<b>Licence Number</b>	L8008/2004/3
<b>Licence Holder</b>	Ravensthorpe Nickel Operations Pty Ltd
<b>ACN</b>	092 506 584
<b>File Number:</b>	DER2014/000631
<b>Premises</b>	Ravensthorpe Nickel Operations Mining tenements M74/114, M74/115, M74/116, M74/123, M74/144, M74/145, M74/173, M74/174, M74/175. RAVENSTHORPE WA 6346
<b>Date of Amendment</b>	27 September 2019

## Amendment

This amendment notice is made pursuant to section 59 of the *Environmental Protection Act* 1986 (EP Act) to amend the Licence (L8008/2004/3) issued under the EP Act for a prescribed premises as set out below. This notice of amendment is given under section 59B(9) of the EP Act.

**Figure 1: Dam 2 location in relation to Halleys waste dump, tributaries, Bandalup Creek and areas of vegetation death and decline**

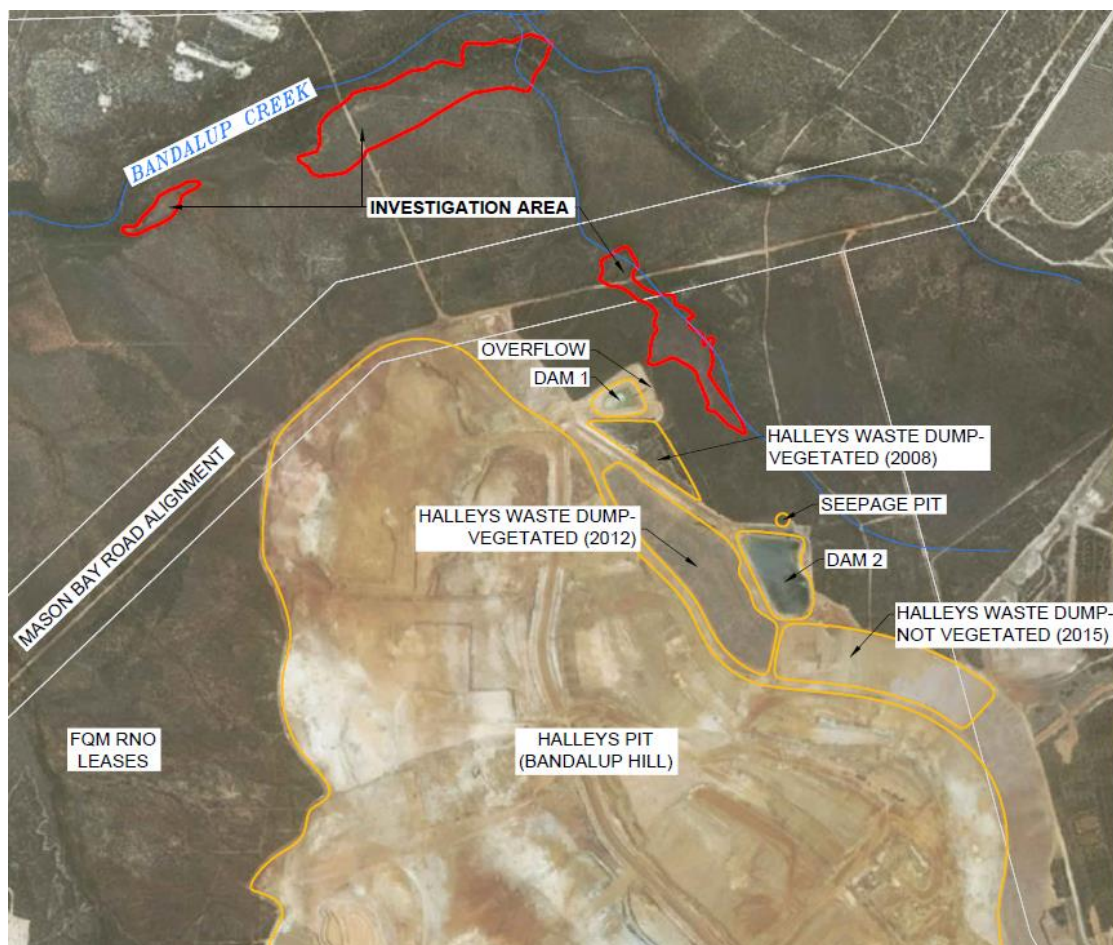
The PDSI concluded that the likely cause of the vegetation decline and deaths was the seepage of and/or overflow of saline water from Dam 2. The impacted areas are located adjacent to several tributaries which feed into Bandalup Creek, one of which originates near the base of Halleys waste dump. The extent of the areas of vegetation death and decline have not been fully delineated to date. Figure 1 below shows Dam 2 in relation to Halleys Pit, Halleys waste dump, tributaries, Bandalup Creek and the investigation areas considered in the PDSI.

The PDSI identified that in addition to saline mine water, Dam 2 receives seepage water from Halleys waste dump. The water seeps from the northern face of the unvegetated portion of Halleys waste dump, flowing on surface soils and discharging into Dam 2.

The water emissions from Dam 2 have resulted in contamination and death and decline of vegetation within and surrounding the premises. The levels of metals in surface water samples taken from the areas with vegetation decline and deaths showed significant exceedances of the 95% protection level trigger values with exceedances of aluminum up to 165x, manganese up to 1.6x and nickel up to 9x.

It is highlighted in the PDSI that a permeability issue was identified at Dam 2 in 2013 which was allowing seepage water to escape. In an attempt to capture the seepage, a pit was excavated along the northern boundary of Dam 2 to allow it to be pumped back into Dam 2 on an as needs basis. The photo log provided with the PDSI indicates that the vegetation in the immediate vicinity of the seepage collection pit exhibited signs of stress.
